UNITED STATES PATENT AND TRADEMARK OFFICE

APPLICATION NO.	FILING DATE	FIRST NAMED INVENTOR	ATTORNEY DOCKET NO.	CONFIRMATION NO.
10/694,772	10/29/2003	Yosuke Miki	71450.0009	6726

Office Action Summary

DETAILED ACTION

FIG. 2

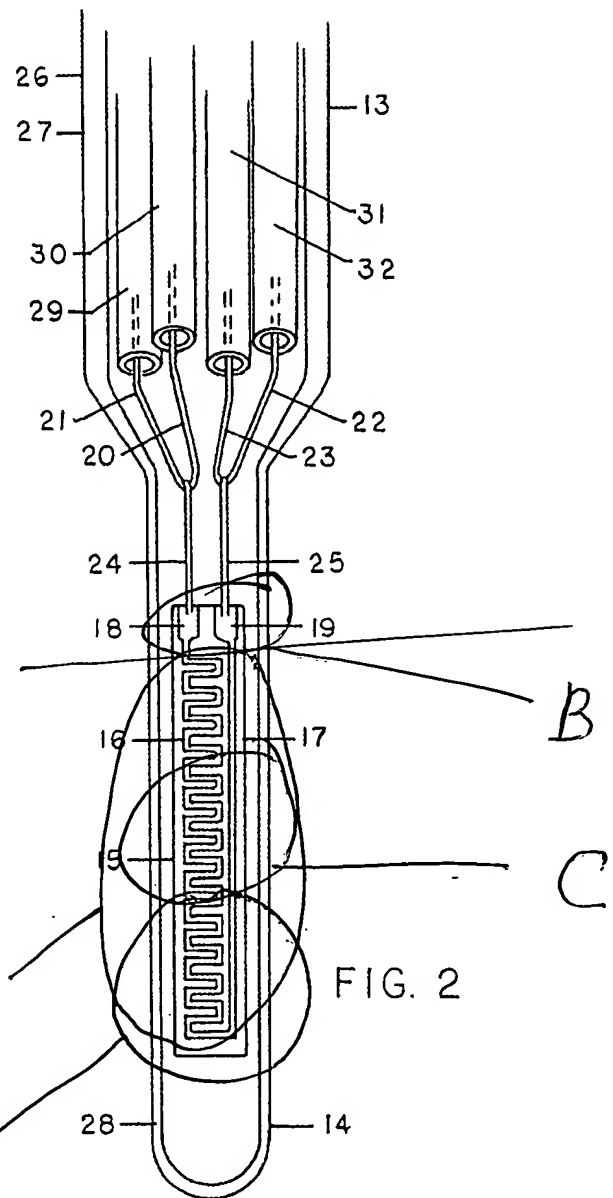
Schermund discloses in Fig. 2 a device comprising a base insulating substrate/board having a conductive layer comprising a temperature detecting portion formed as a wiring made of a thin film platinum/ metal foil) 16 formed in a serpentine pattern (wiring folded in such continuous form that adjacent parts of the wiring parallel are spaced apart from each other at a predetermined interval), as shown in Fig. 2. The

portion 16, inherently, changes its resistivity (specific resistance) proportionally to a temperature change. As shown in Fig. 2, the conductor layer formed entirely to the base insulating layer in a predetermined (desired) pattern, wherein the base insulating layer has a generally rectangular flat strip shape (thin) with generally rectangular widened end portions A, B and a central portion C. The conductive layer, inherently, changes its resistance (specific) proportional to a temperature change.

The base insulating layer is formed on to one side (under one side) of the conductor layer. The temperature-detecting portion D is formed on the top of the base insulating layer at the generally rectangular flat widened portion A. (The numerals A-D have been added by the examiner, see attachment # 1 to the Office action).

(attachment #2)
06 07/08/05

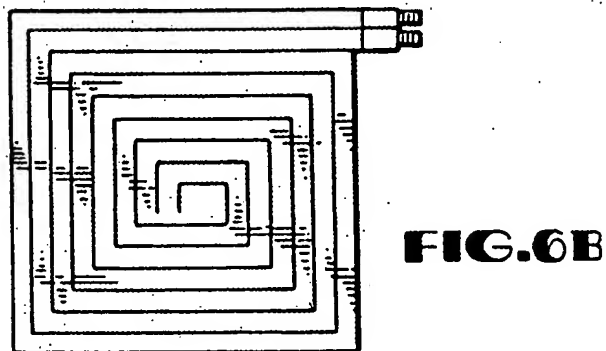
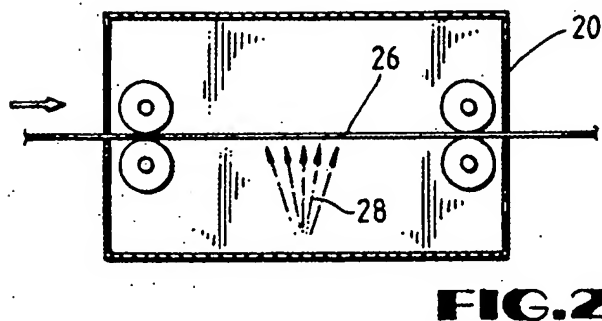
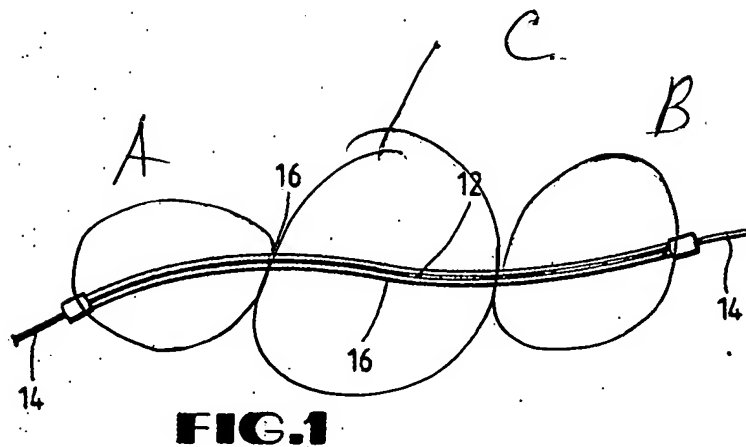
Kiec discloses in Figs. 1 and 6B a flexible wired board/ device/ RTD comprising a base insulating layer/ barrier 16, a cover insulating layer/ barrier 16, a conductor layer comprising a resistive pattern/ metal foil/ film (temperature measuring sensor-wiring) 12 formed onto the base insulating layer 16 and covered with the cover insulating layer 16, and a main wiring (leads) 14. The resistive pattern 12 can be a serpentine shape, as shown in Fig. 6B, or any desired shape (col. 10, lines 1-12). Kiec states that any metal could serve as the resistive pattern 12 of the conductor (col. 5, lines 49-50). The base insulating layer has a generally rectangular flat strip shape (thin) with generally rectangular widened end portions A, B and a widened central portion C. The temperature measuring sensor wiring, as shown in Fig. 1, is positioned on the base insulating layer at its widened flat end portions and at its widened flat central portion. (The numerals A-C have been added by the Examiner, see attachment # 2 to the Office action).

FIG. 2

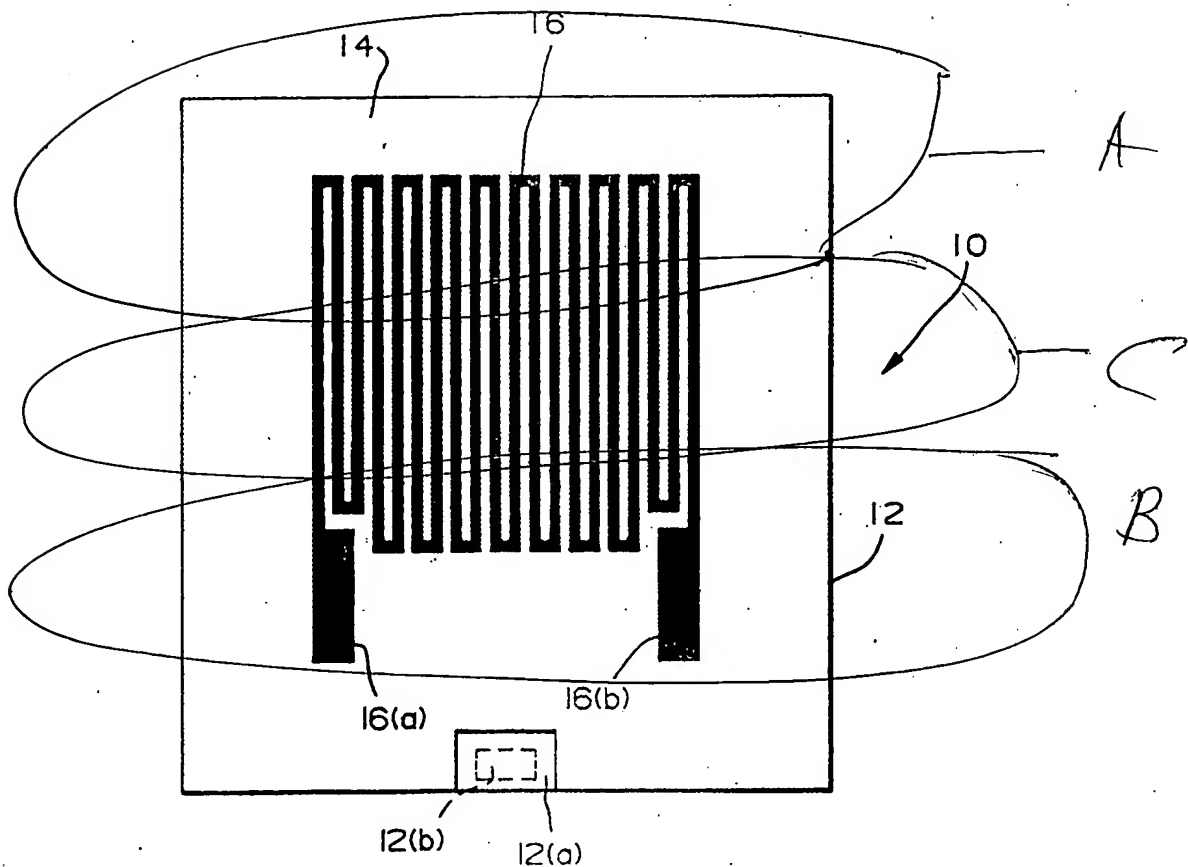
Schultz discloses in Fig. 2 a device/ circuit board for measuring temperature.

The device comprises a conductor layer (metal foil) 16 formed in a serpentine shape (continuous shape, as claimed by applicant) and comprising a temperature measuring wiring 16 and a main wiring 16a and 16b. The temperature sensing wiring 16 is substantially positioned on one end portion A of a generally rectangular base insulating layer 14 attached one side (bottom side) the conductor. The main wiring 16a and 16b is positioned on the another end portion B of the base insulating layer, wherein, the base insulating layer comprising flat widened end portions A and B and a flat widened central portion C (the numerals A-C have been added by the examiner, see attachment # 3 to the Office action).
